The proposed campsite at Loch Achray – what lessons has the National Park learned?

In September the Loch Lomond and Trossachs National Park Authority submitted a planning application (see here) to itself as planning authority for a new campsite on the south shore of Loch Achray on Forest Drive in the Trossachs. There is widespread agreement that new campsites with basic facilities are needed in the National Park. So far the LLTNPA has been poor at delivering these. It appears to have abandoned the excellent Five Lochs Plan (see here for example) which proposed a number of new campsites in the Trossachs and has also failed to deliver a new campsite this year on the south shore of Loch Earn. This application therefore is welcome. In this post I will look at what the LLTNPA has learned from its experience at Loch Chon and the camping byelaws to date.

Map showing location from planning portal

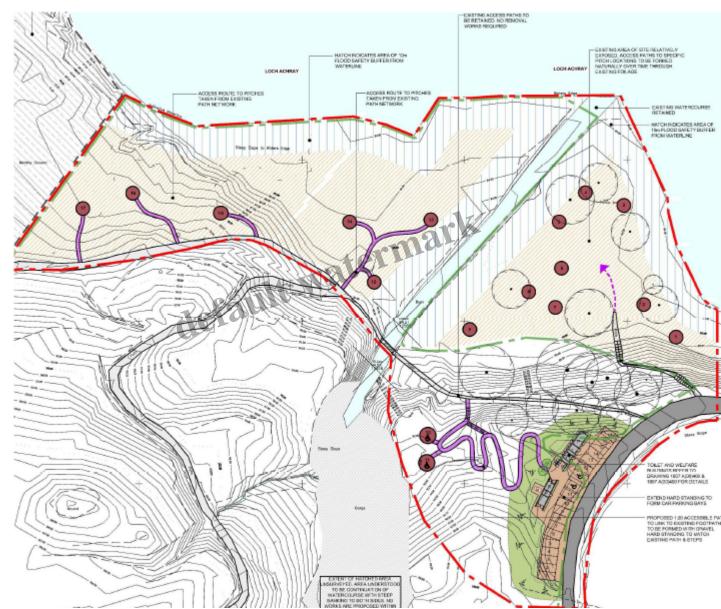
However, you can see from the campsite plan above that the LLTNPA is still wedded to the idea of fixed camping pitches and what is even worse they appear to wish to replace the grassy sward with

bark. That is not a traditional camping pitch, its suburbanisation. The Park would be far better to abandon any idea of fixing camping pitches in this area and allowing people to camp where they choose. This would also enable areas of bare ground to recover. All the Park would need to do to manage this is to put up signs by worn areas asking people to choose a less worn area to pitch their tent (this is how it should be dealing with erosion throughout the Park – there is no need to ban people to protect vegetation).

Three of the places (far left of map above) are in woodland up on the hill well away from the loch. To provide camping places here will require the creation of paths and pitches like at Loch Chon. I suspect the main reason for these pitches is to enable the Park can claim to have provided a certain number of new camping places – its target, which it has failed to meet, was to provide 300 new camping places in the first year of the camping byelaws.

site plan) the LLTNPA is proposing to provide a further 3 places. This is much closer to the loch than the proposed pitches on the hillside but the edge of the lochshore here is boggy, the ground itself boggy in places and has become overgrown. This perhaps explains why there is little sign of people camping here at present. It could though potentially provide good camping places with some engineering. While not designated as ancient woodland some of the fungi on the trees are fantastic. I would like to see mimimal path creation, with importing of hardstanding materials limited to the boggy areas., to keep it as natural as possible.

The site includes proposals for two camping pitches suitable for people with wheelchairs (bottom of site plan). Its very positive the Park is including facilities for people with disabilities, who are too often excluded from enjoying the countryside, but its unfortunate because of the very steep approach to the loch shore disabilities that people with disabilities will in effect be segregated from other campers (bottom two places in diagram). I hope the places get used. What the LLTNPA should be doing is consulting organisations representing people with disabilities to ensure it has got this right (there are no disability or recreational organisations on the list of those consulted).
